## SERVICE BULLETIN REVISION TRANSMITTAL SHEET

TITLE: WINGS - GENERAL - ONE TIME INSPECTION OF TAPERLOK BOLT AT

WING TO FUSELAGE JUNCTION.

This page transmits Revision No.03 of Service Bulletin No.A320-57-1140

Figure A-FCEAA - Sheet 01
Inspection of the Fasteners for the ADDITIONAL WORK

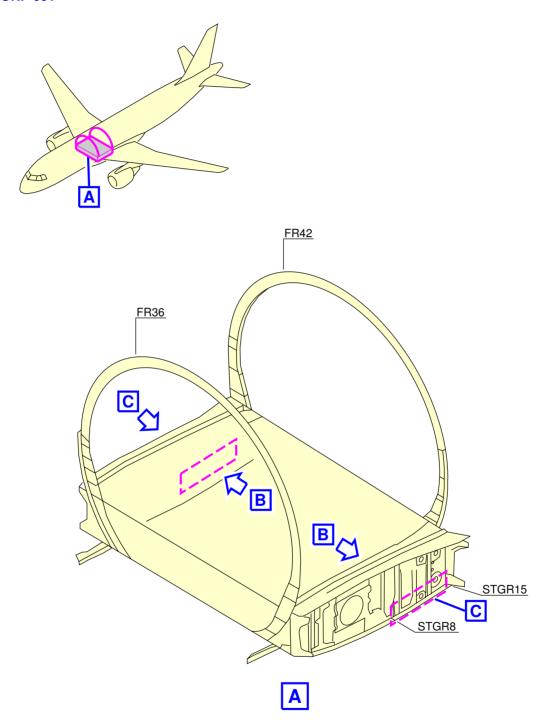
The ADDITIONAL WORK consists in inspecting new fasteners located in the center and outer wing box in the Rib1 area.
